CA# CA1215 **Case File:** GH-1-10

Case File / Name: GH-1-10 / Oberlin Road Condominium

Nature of Case: This request is to approve a group housing development consisting of 8 units in 3

GH-1-10 Oberlin Road Condominiums - site plan

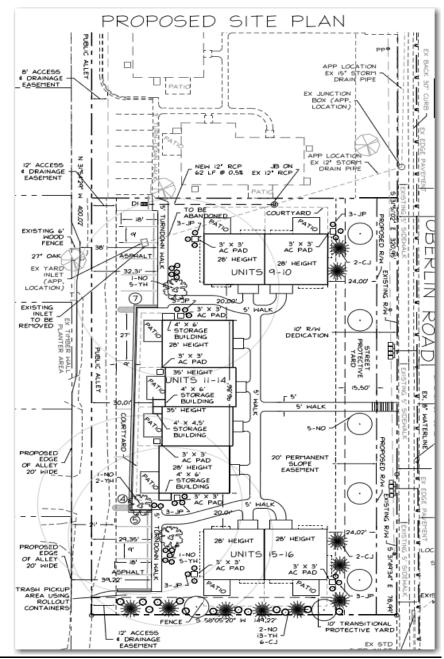
Comment Response The committee recommends that the street Plan revised to show additional landscaping presence of all building elevations facing and HVAC units relocated more behind the Oberlin Road be carefully considered (e.g. unit with additional screening that utility and HVAC units screened or relocated away from street view). Given the predominance of oaks in the Nuttall Oaks used instead of red maples as immediate vicinity, and the ample ground shown on the landscape plan. available for planting along Oberlin Road, substitute a locally-adapted Oak variety for the proposed red maples.
